AGENDA
HISTORIC DISTRICT COUNCIL
REGULAR MEETING
SEPTEMBER 19, 2024
5:00 PM
CITY HALL COMMISSION CHAMBERS
204 ASH STREET
FERNANDINA BEACH, FL 32034

HISTORIC DISTRICT COUNCIL STAFF REPORT
HDC 2024-0020
SEPTEMBER 19, 2024

3
A301
EXTERIOR ELEVATION
EAST EXTERIOR ELEVATION
1/4" = 1'-0"

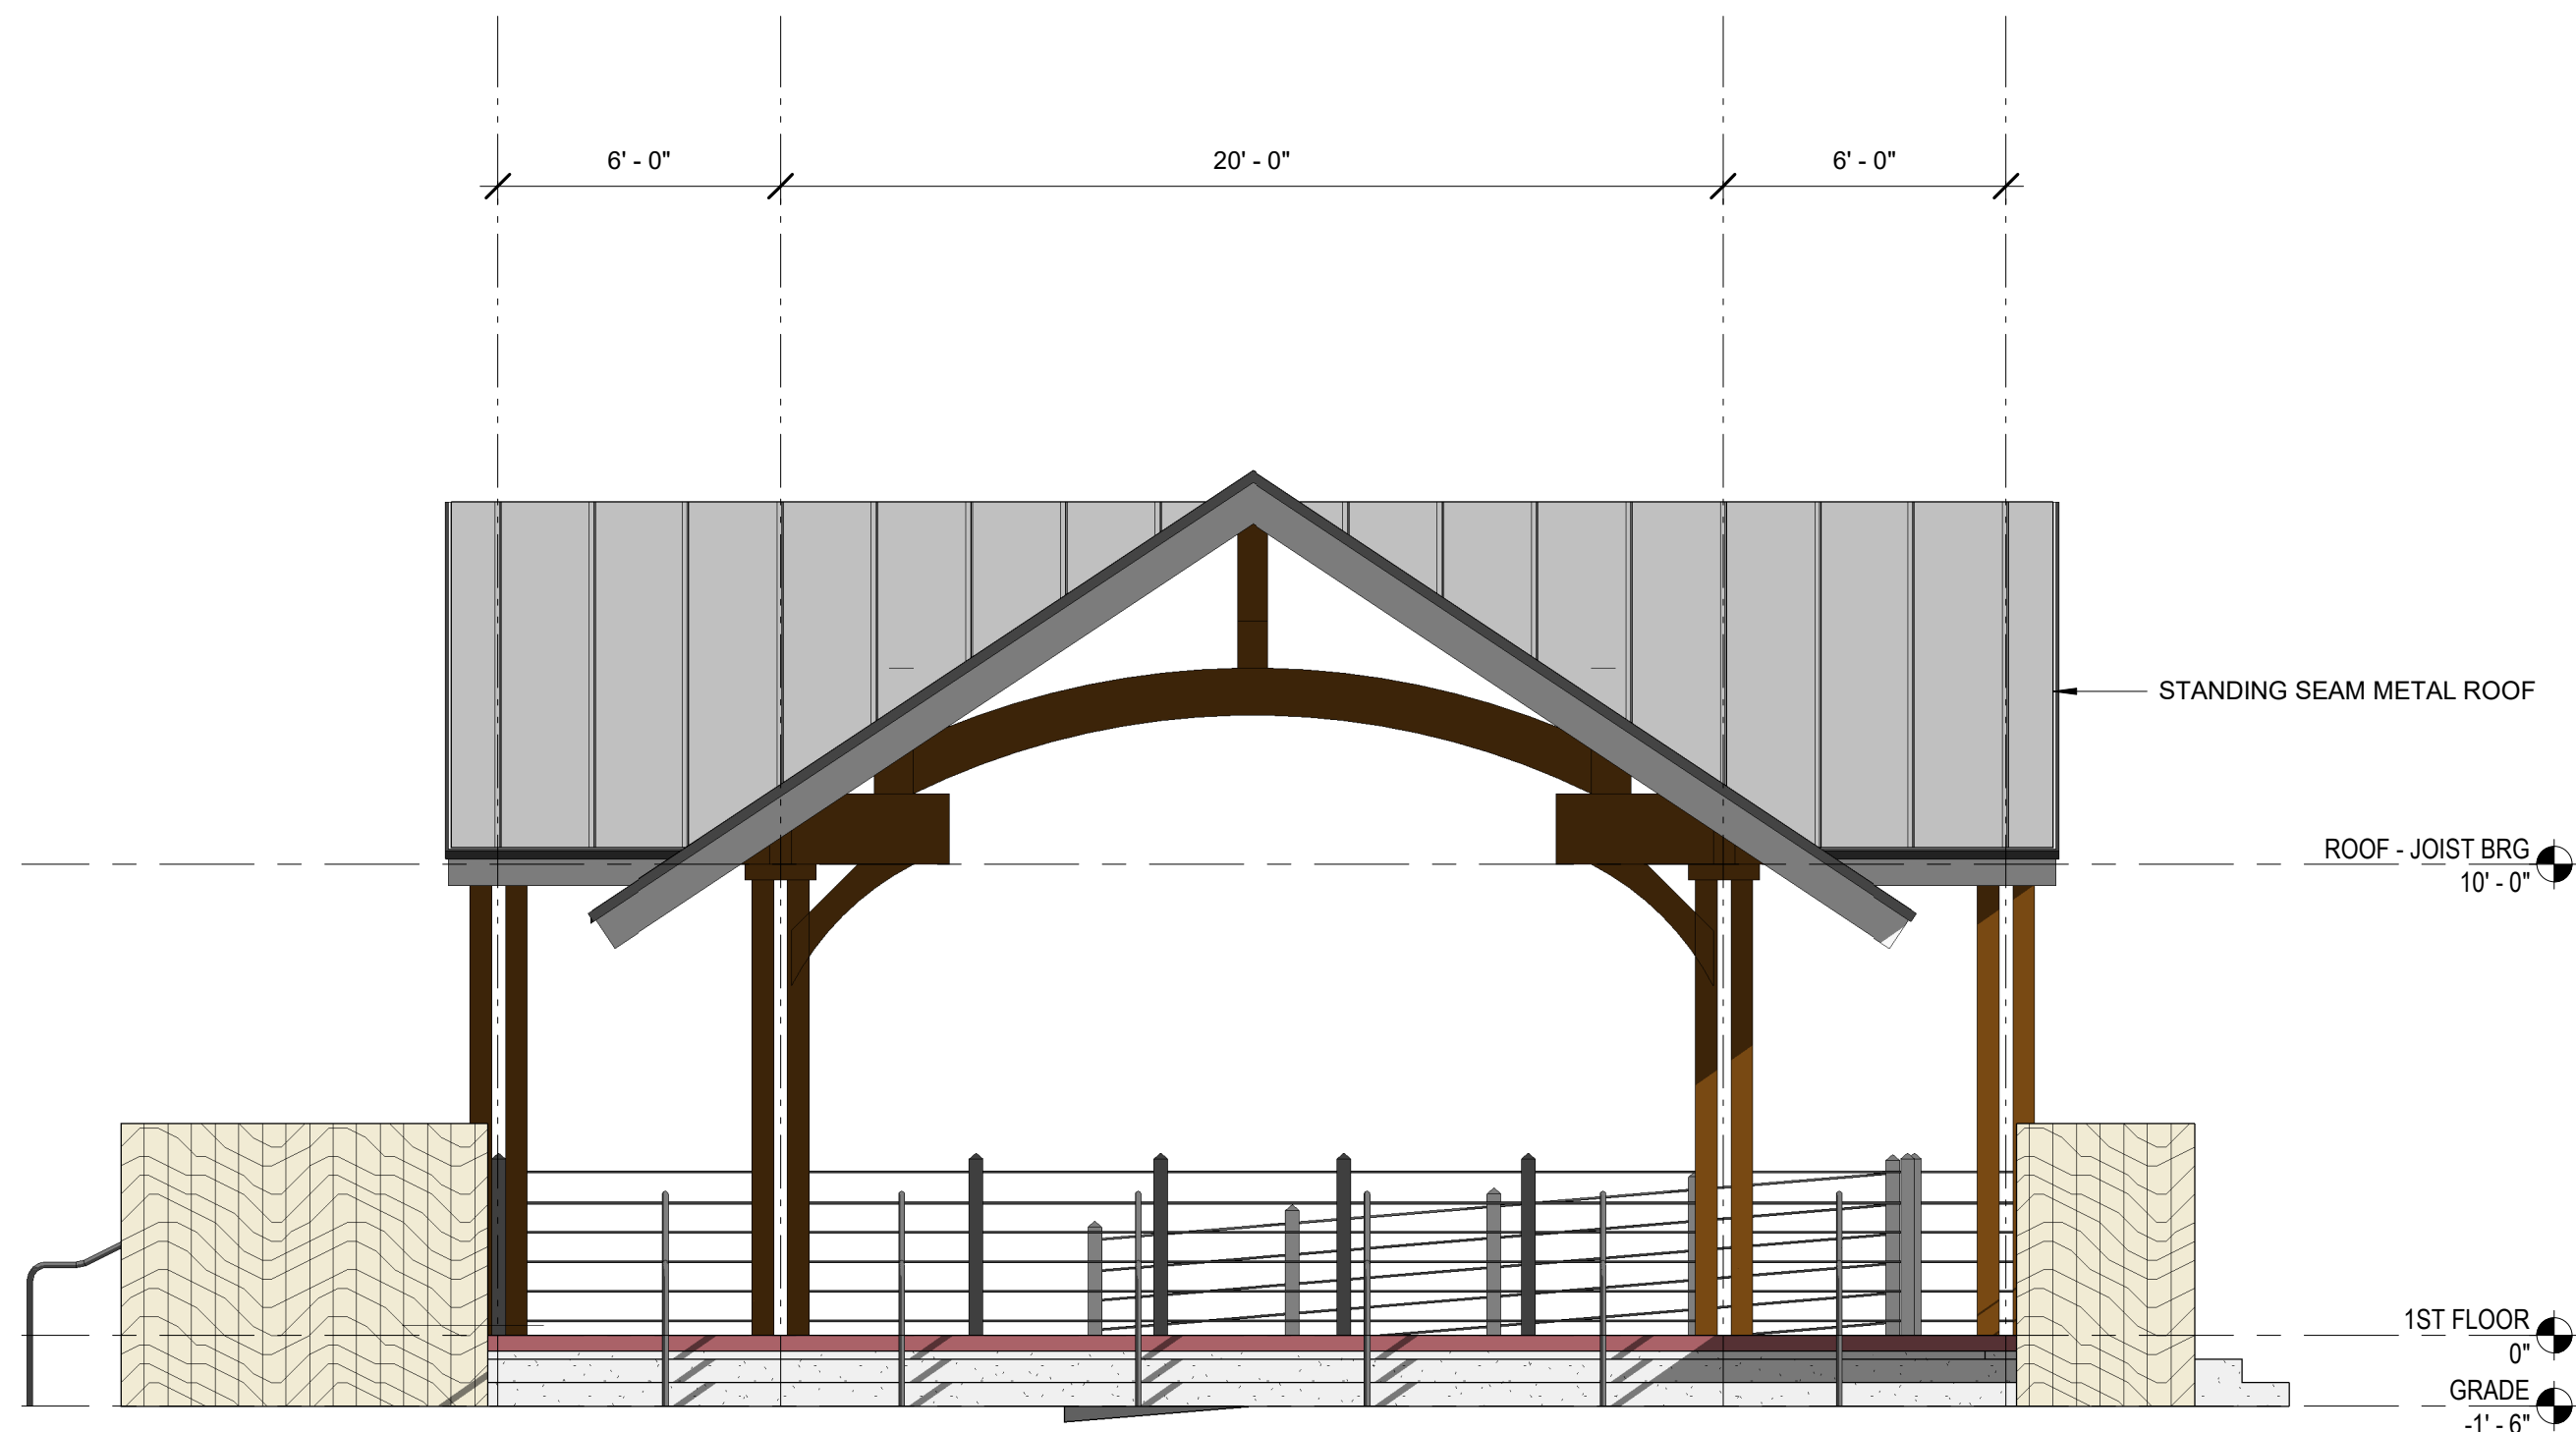
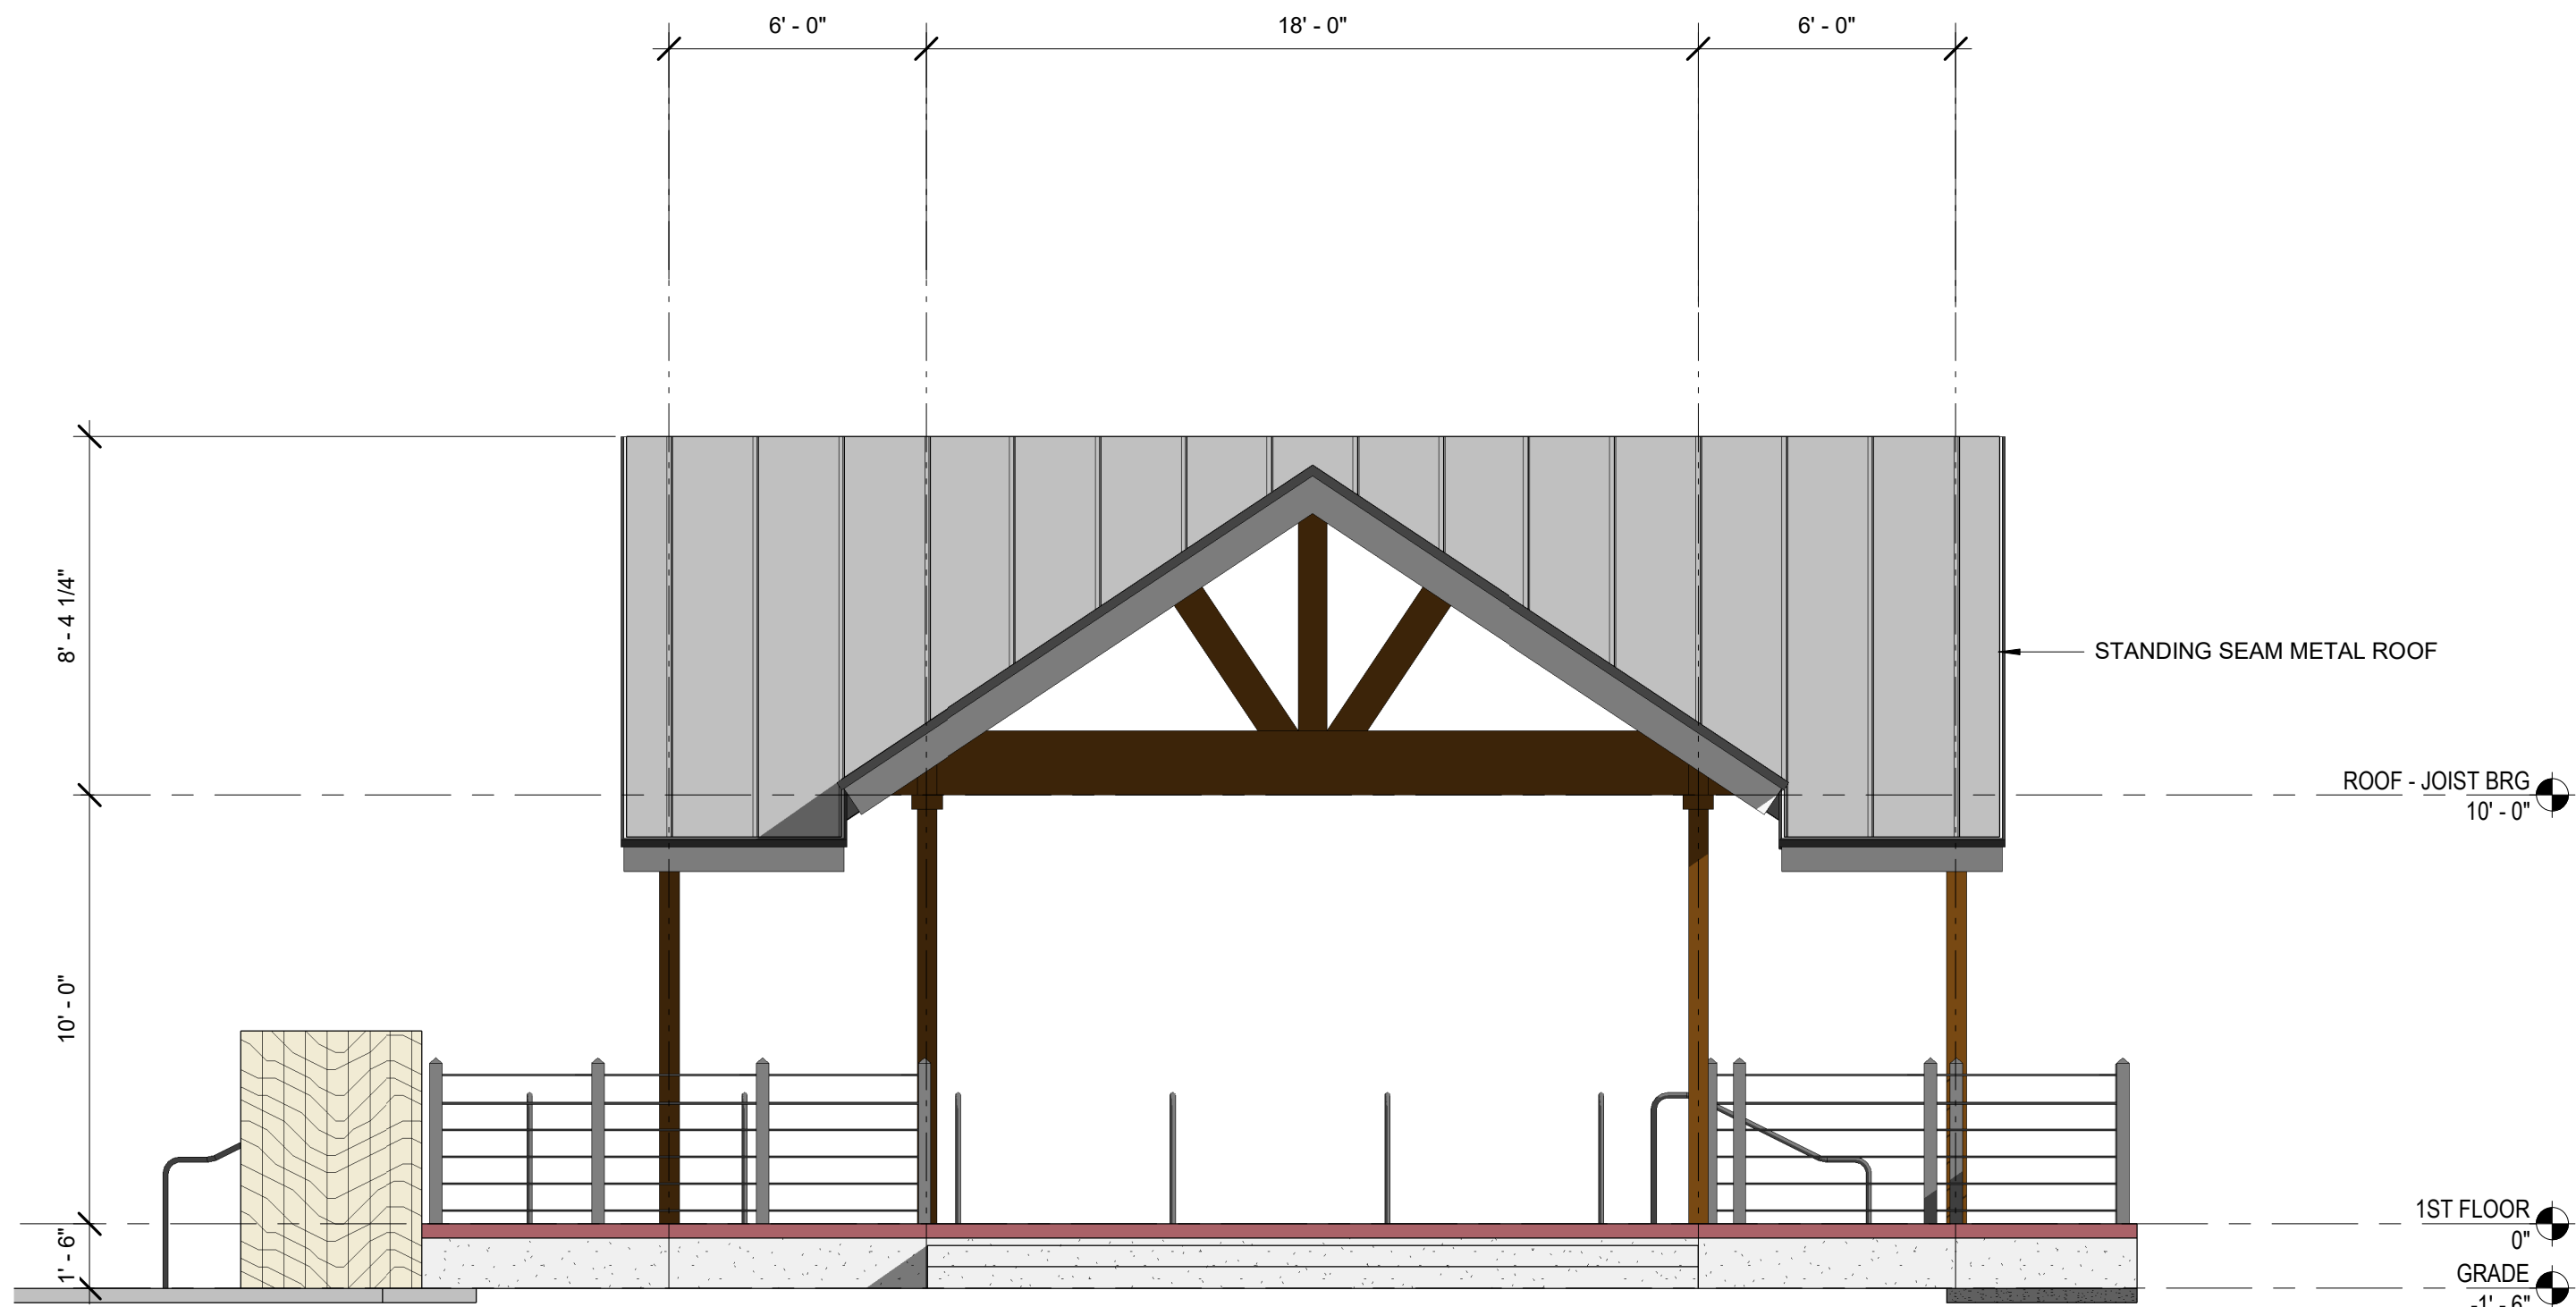
Lisa Finkelstein, Chair of the CRA Advisory Board, addressed the concerns of the Board at the June 27, 2024, previous meeting. She noted the removal of the concrete planters, the spoke of the height concerns, the ramp, the

bracketing style, the railing cabling, the wood stamped concrete, the flooring materials, and a larger landscape plan.

The Board discussed these proposed modifications further and suggested simplifying the design, which in turn would reduce costs and help better integrate the structures into the existing environment. They also asked to consider that the final pavilion design ties in with the upcoming Atlantic Seafood project design.

The design of the waterfront and these elements have not been provided to the TRC for technical consideration. This is a necessary next step which must be completed before the issuance of any building permits.

DESIGN OBJECTIVE	To create an architecturally iconic pavilion that reflects the Victorian architecture of Fernadina's Historic District (lap siding, steeply pitched roofs) combined with a working waterfront aesthetic (metal roofs, minimal ornamentation, maritime references), consistent with the CRA Design Guidelines.
COMPATIBILITY	These recommendations will make the pavilion & restroom building architecturally compatible.
SITE PLAN	Site plan shows stairs on the west side overlapping the floodwall. Adopt CRAAB pavilion floor plan and site plan
BUILDING HEIGHT	25' from grade.
ROOF	PITCH - 12/12. EAVES - Bottom edge of roof should align around all four sides. OVERHANGS - 18" minimum. STANDING SEAM METAL - Style and color OK. GUTTERS & DOWNSPOUTS (or rain chains) - Add at each corner. Downspouts should go through the deck to ground below. (Match to Train Depot pavilion gutters and downspouts). SKYLIGHTS - Add four skylights to north/south roof near junction of east west dormers, to bring light into the interior.

GABLES	To reduce rain incursion into the pavilion and to make the design compatible with Historic District architecture, infill gable ends with lap siding and triangular openings at top of gables for light and air flow. Infill south gable end with a circular opening in the lap siding. (Circular opening establishes the front of the pavilion and is a metaphorical sunset).
COLUMNS	8x8s, no double columns.
DECK	Remove northwest corner of deck per CRAAB floor plan. Brazilian Ipe wood decking OK. Eliminate brick and make entire deck Ipe.
STAIRS	Concrete Steps and Edge Ribbon OK. Three steps with 7" risers, so deck height is 21". (Since pavilion will be used for stage performances, increased height of the stage and deck is needed).
ADA RAMP	Should be 21' long x 5' wide. Ramp will also be used to move equipment for stage performances, so wider width is necessary.
RAILINGS	Cable OK, with 4x4 posts. Add minimal top rail.
